SERVICE BULLETIN SB-50

SUBJECT: R44 II Oil Line Clamp

ROTORCRAFT AFFECTED: R44 II Helicopters S/N 10001 thru 10157 except S/N 10033, 10092, 10140, 10143, 10147, 10150, 10151, 10152, 10154, 10155, and 10156.

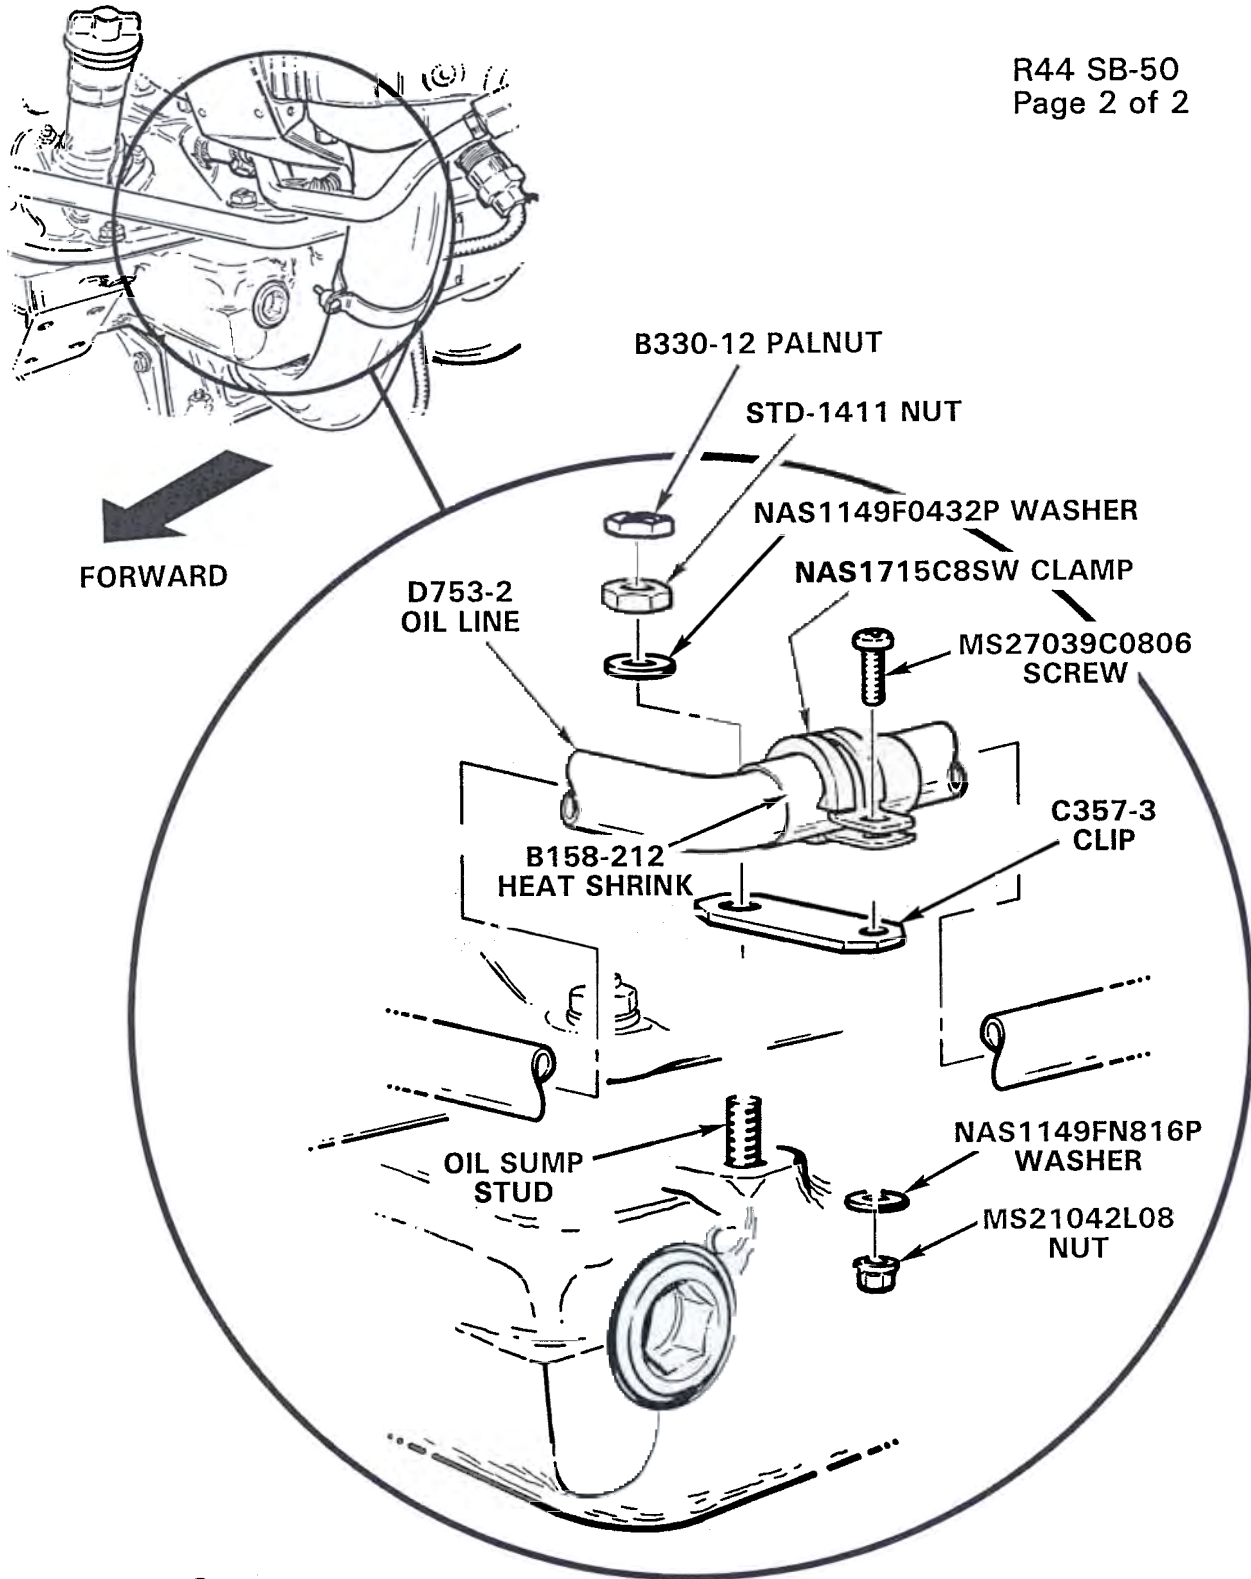
BACKGROUND: Excessive vibration has been observed on the auxiliary oil cooler supply line on some engines. The vibration is eliminated by adding a second clamp to the oil line.

- 1 Remove left-hand engine cowling. Refer to figure on page 2
2. Disconnect D753-2 oil line's forward nut, slide nut aft, and clean oil line in area where clamp is to be installed.
3. Slide B158-212 heat shrink over forward end of oil line, exercising care to prevent oil contamination. Center heat shrink at oil sump stud and activate with heat gun.
4. Reconnect oil line nut. Torque to 450-500 in-lb and torque stripe.
5. Install C357-3 clip as shown in figure and secure with NAS1149F0432P washer and STD-1411 nut torqued to 96 in-lb. Install B330-12 palnut and torque to 11-25 in-lb.
6. Install NAS1715C8SW clamp on oil line and secure to C357-3 clip using MS27039C0806 screw, NAS1149FN816P washer, and MS21042L08 nut as shown in figure.
7. Ground run helicopter and verify no oil leaks.
- 8 Install engine cowling.
9. Make appropriate maintenance record entries
